December 6, 2019

PROJECT NUMBER 17163

**Re: D12-444 D14-1674 750 Lockhart Road – Response to Comments
Draft Plan of Subdivision**

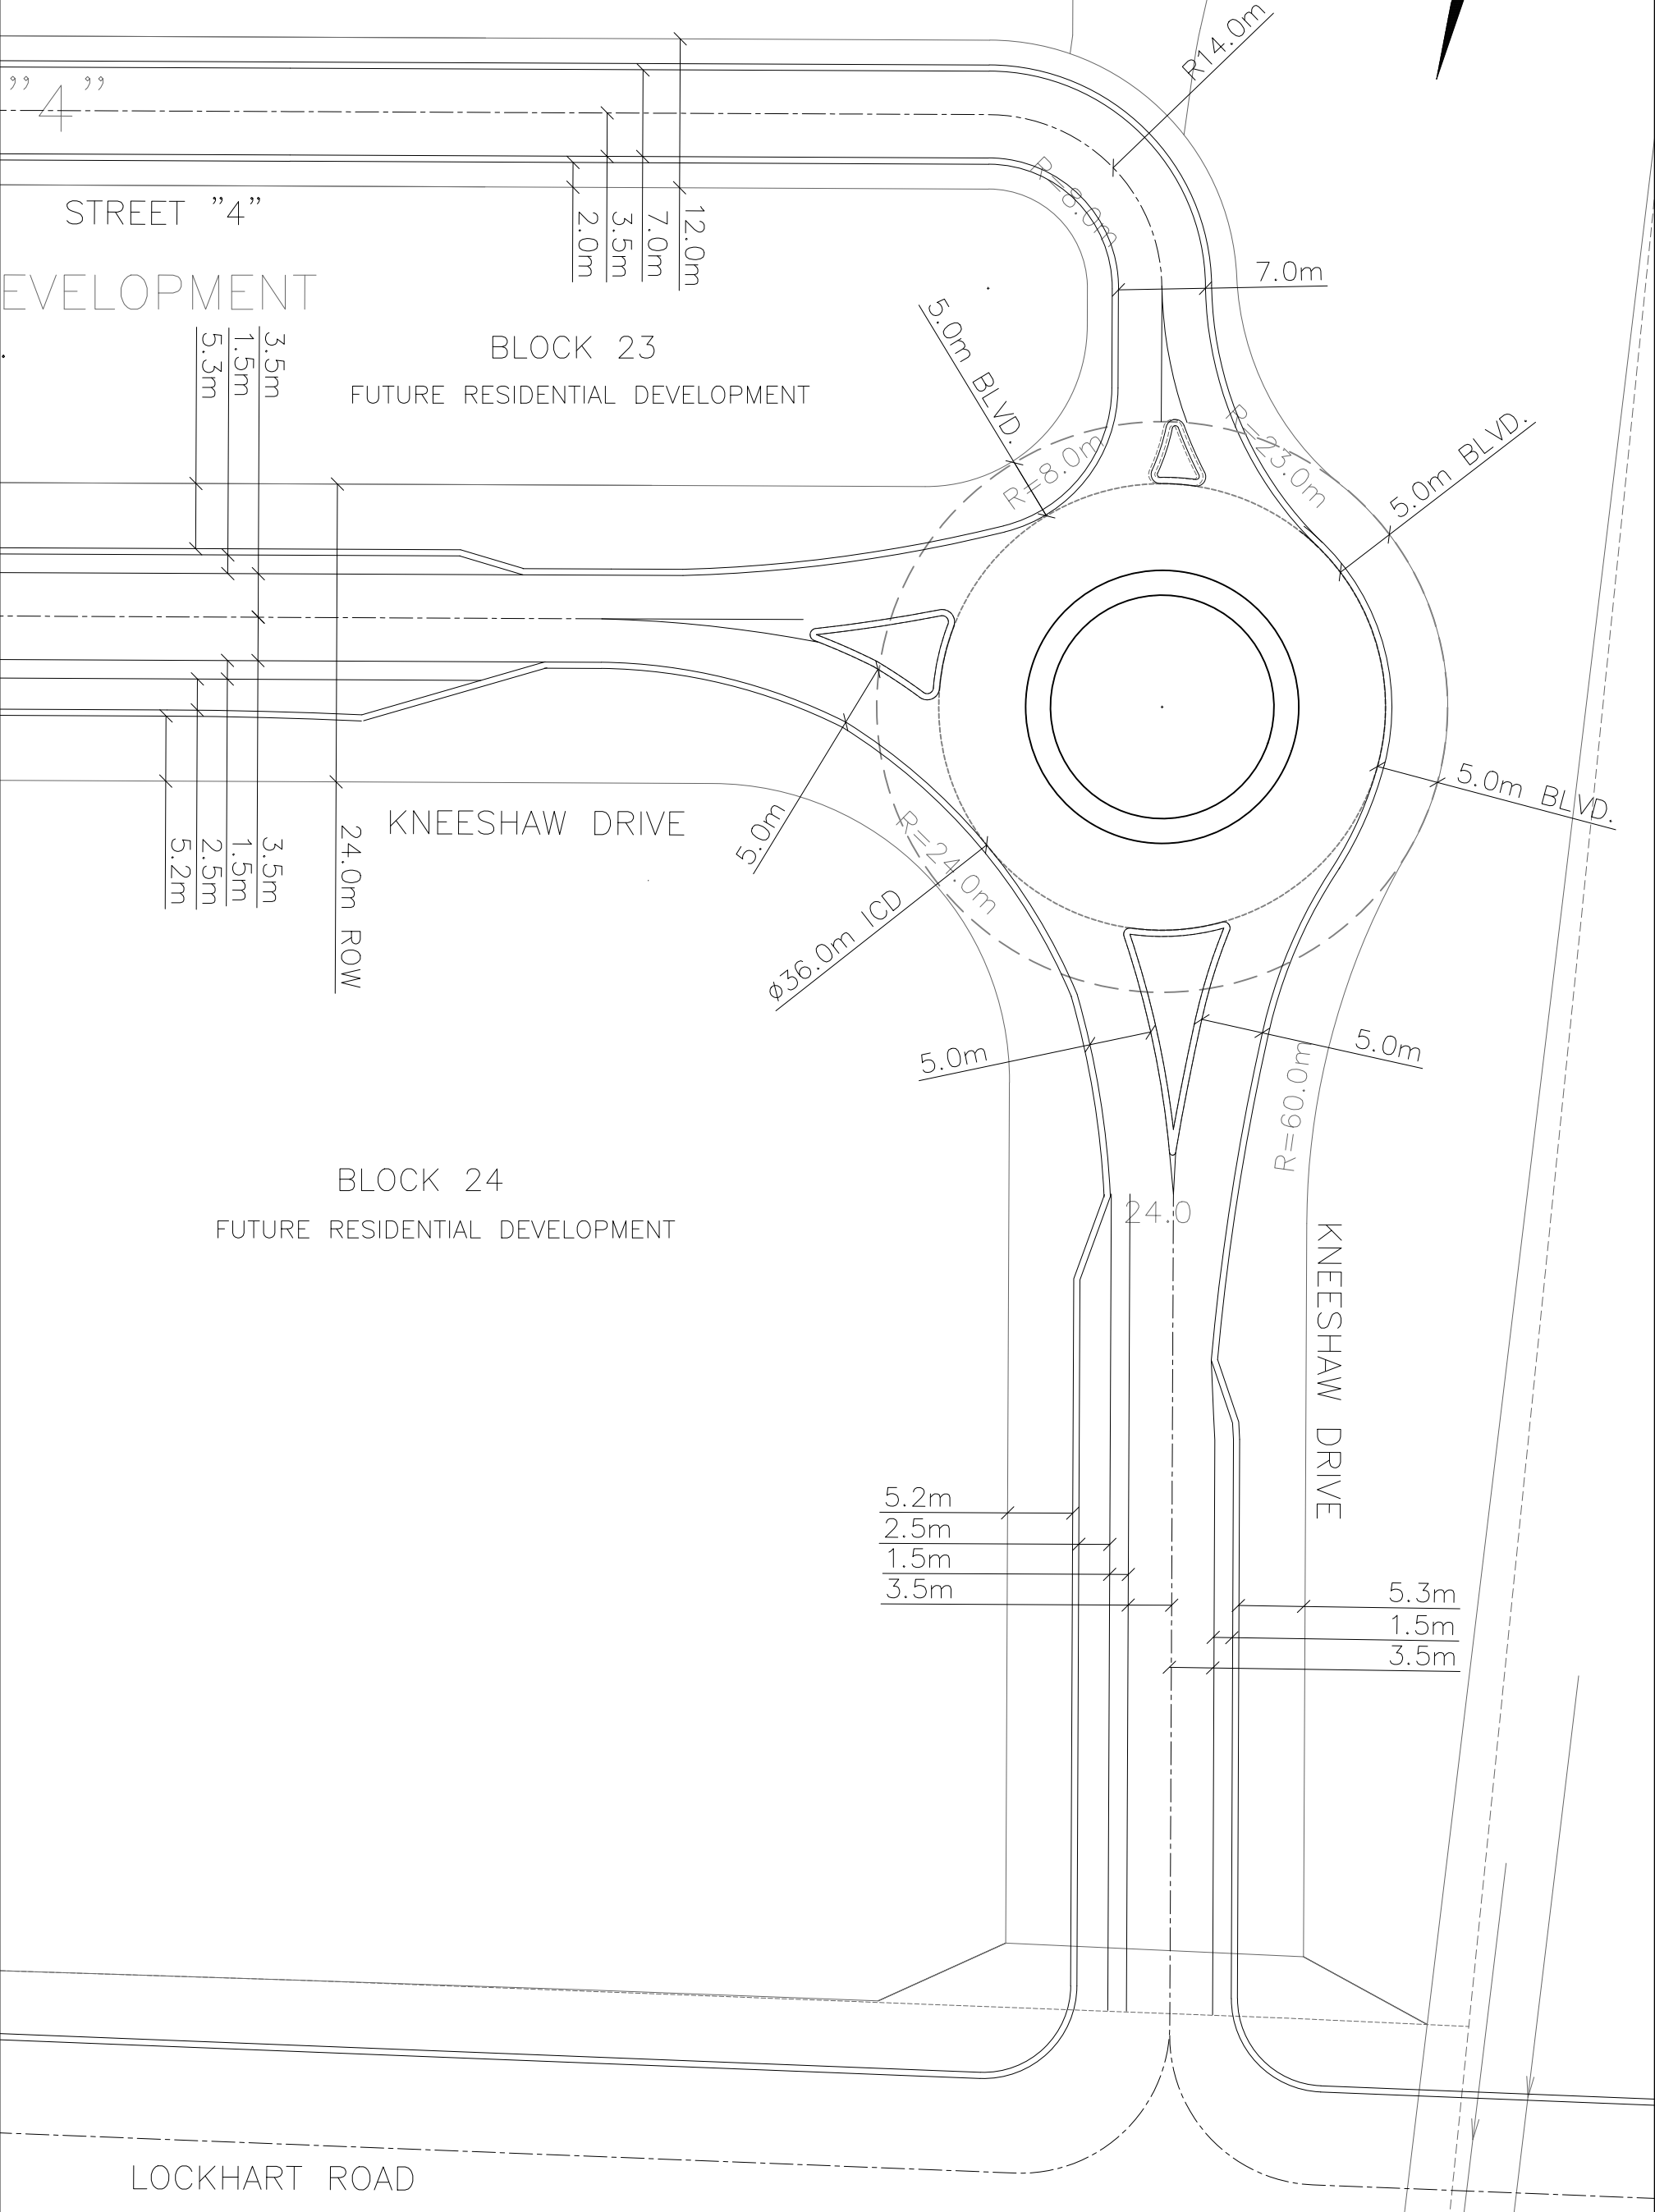
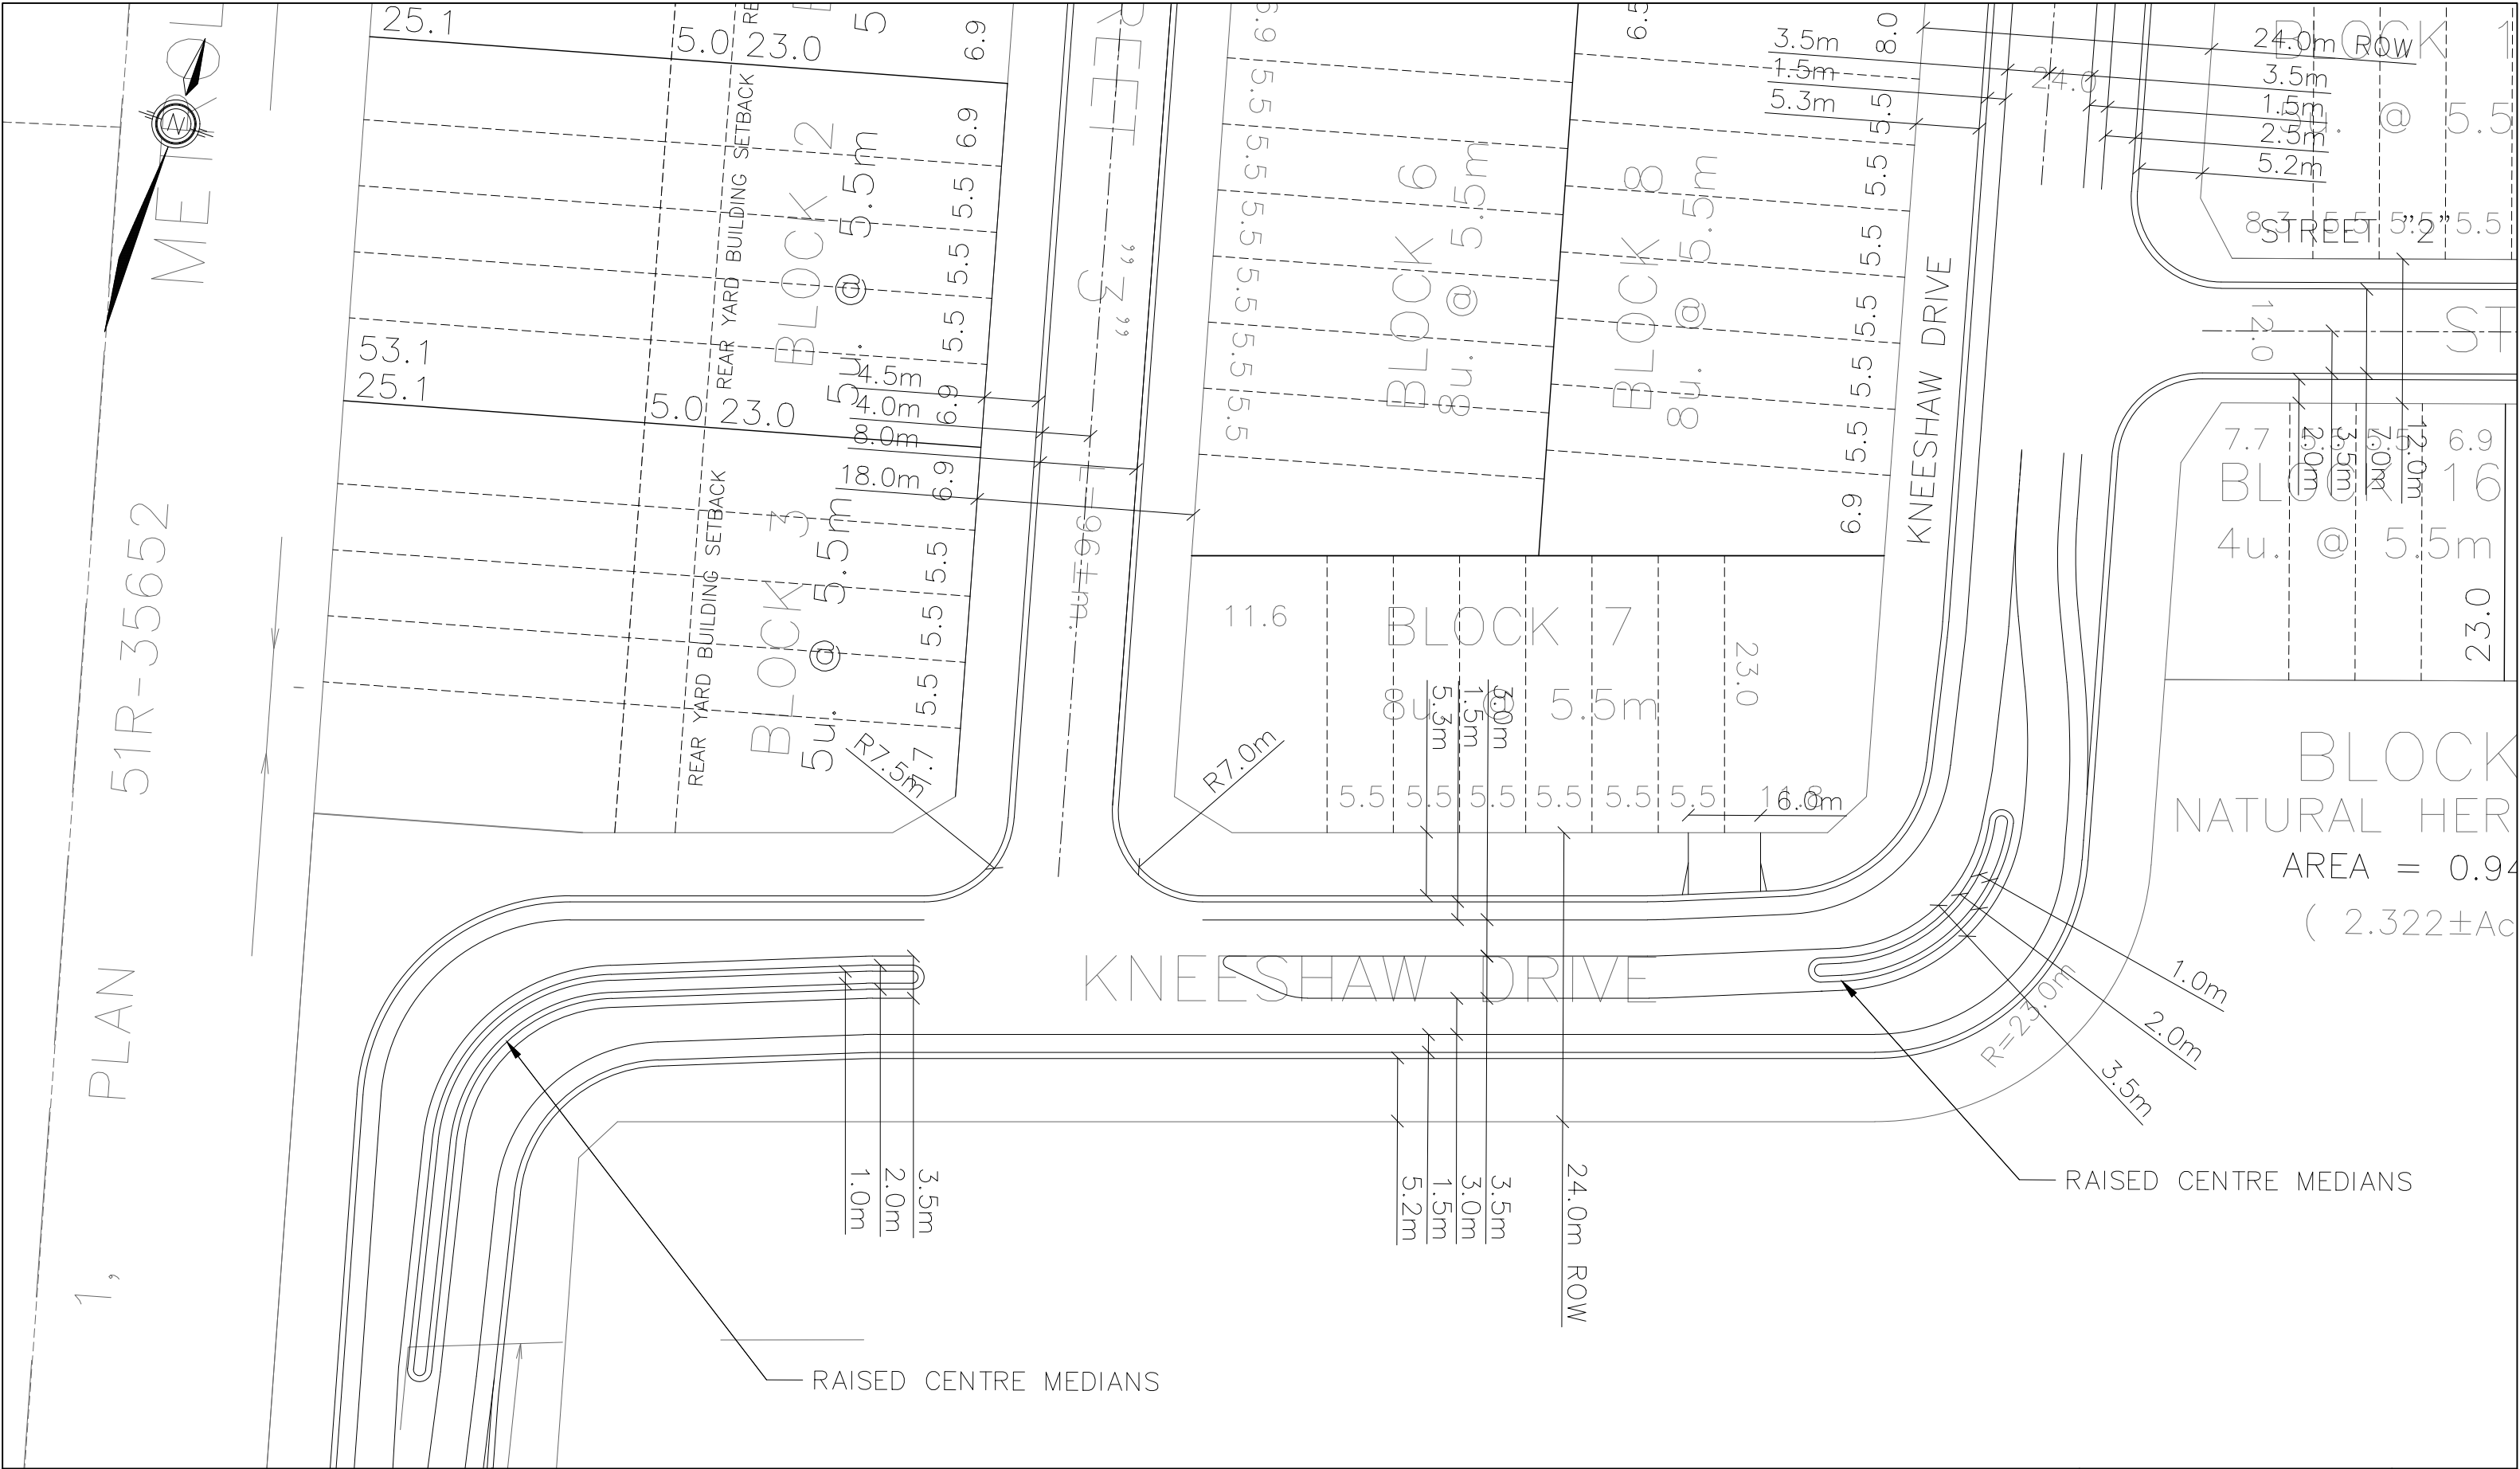
Comment 2: Staff recommend the proposed western median island to be reduced to the west to permit a left turn lane onto Street 3. This is to remove the potential delay for vehicles waiting to turn left onto Street 3 which will impede the through movement.

Comment 3: Identify the driveway placement for the easterly lot on Block 7 to ensure there is no conflict with the proposed easterly median island.

*Response: After discussion with the City of Barrie, this is no longer a concern. The western median is more than 10 meters away from the centre of pavement on Street 3. However, further to TMIG's discussions with City staff, the Kneeshaw Drive pavement markings located south of Street '2' were modified by removing the 'median' pavement markings in front of Block 8. The raised concrete median was subsequently shortened (to the south) to accommodate the revised markings (see attached updated **Figures CD-1 and CD-4**).*

*Response: Attached **Figure CD-4** identifies the 6.0m wide double driveway placement for the easterly lot on Block 7. Please see attached passenger vehicle movement diagrams (**VMD-14** and **VMD-15**) that show no conflict for passenger vehicles with the proposed easterly median island.*
